Re: Ronald Reagan Blvd. (Phase IV) construction project
Austin White Lime (Parcel 1)—driveway cost reimbursement

EXHIBIT "A" TO LETTER AGREEMENT

EXHIBIT “B” TO LETTER AGREEMENT

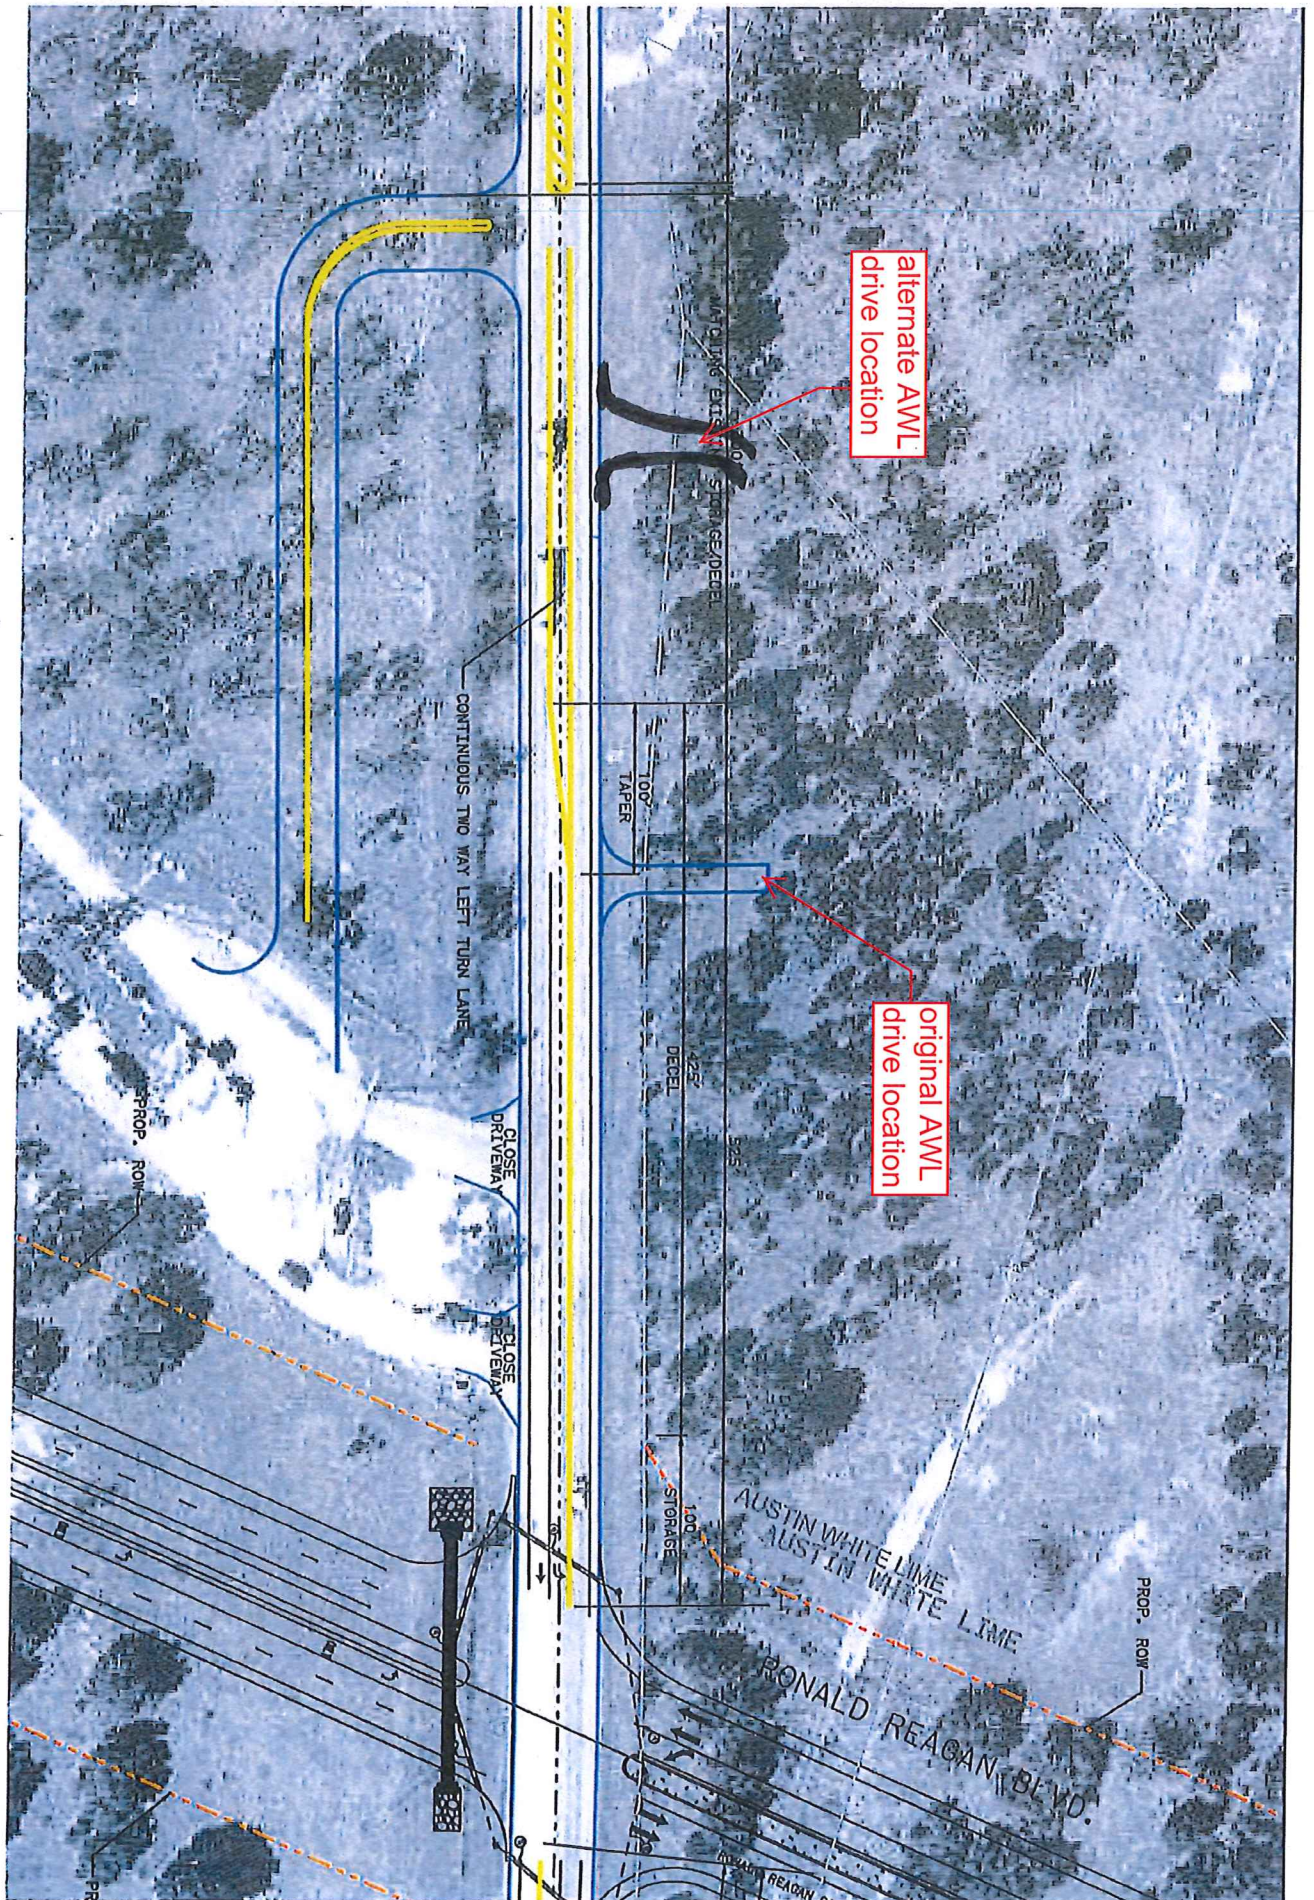
TxDOT had originally approved a permit for the replacement driveway to be located approximately 500’ west of RRN4. However, in order to facilitate a location better suited for adequate drainage across the driveway, AWL has now proposed to cause the driveway to be constructed approximately 700’ west of RRN4 as shown on Exhibit “A” attached hereto. The TxDOT Georgetown Area office has approved this alternate location of the driveway.

Because this alternate driveway location is situated in close proximity to the adjoining property, it has become necessary to modify the pipe fencing and width at the proposed driveway entrance, which was a cost that was unanticipated at the time of the original driveway cost reimbursement agreement between the parties.

I met with Will Pitts in the field on Monday to look at this, and agree that the driveway is about 200' east of the permitted location, which puts it closer to the property line and the next driveway to the east. However, I discussed with Gerald Pohlmeier in the TxDOT area office today, and he is ok with the new driveway remaining in its current location since this section of 195 will soon have reduced traffic when the new 195 roadway opens to traffic.

Since TxDOT is ok with the location, realigning the gate entrance by shifting it slightly to the east seems to be the easiest solution. I don't think I've seen an estimated cost for that yet, but it should be fairly minimal.

As a result, County now agrees to pay AWL the amount of **\$1,000** for the additional cost to remove and redrill the pipe fencing and create additional width at the alternate driveway location identified herein, and as supported by the bid correspondence from Pitts Construction attached hereto as Exhibit “B”.

Thanks - the cost will be \$1000 to remove and redrill the Pipe fencing

We will extend the offset back & east 6ft

We will also add base 6ft to the east for a widened Drive
